MIL-F-63229 (AR)
AMENDMENT 2
26 APRIL 1984
SUPERSEDING
AMENDMENT 1
8 September 1983

MILITARY SPECIFICATION

FUZE, PIBD, XM740, SHOCK WAVE SENSOR FOR

This amendment forms a part of Military Specification MIL-F-63229 (AR) dated 17 August 1979, and is approved for use by the U.S. Army Armament, Munitions and Chemical Command and is available for use by all Departments and Agencies of the Department of Defense.

FIGURE 1 - Direction of Applied Acceleration

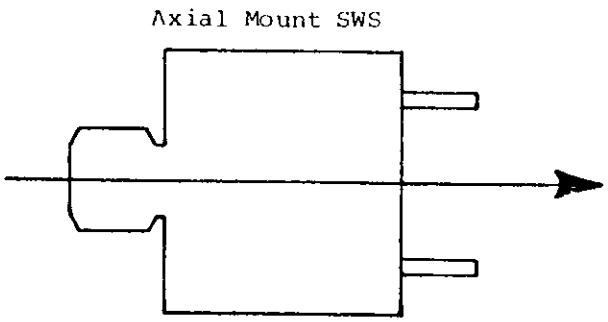
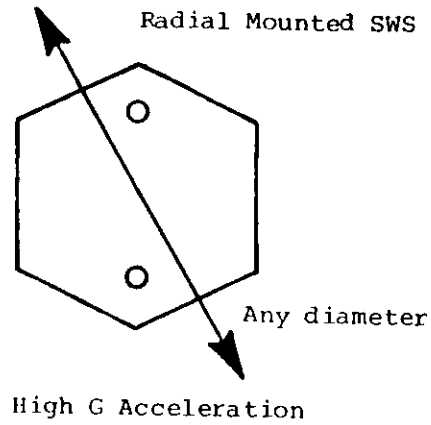
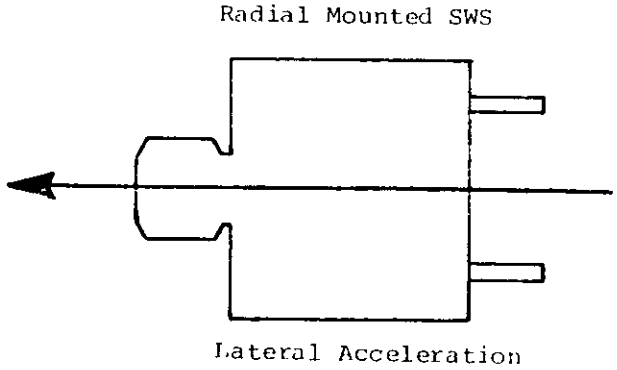
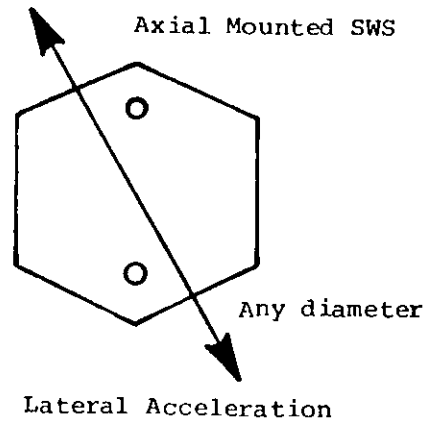
Figure 1: Delete in its entirety and substitute the following:
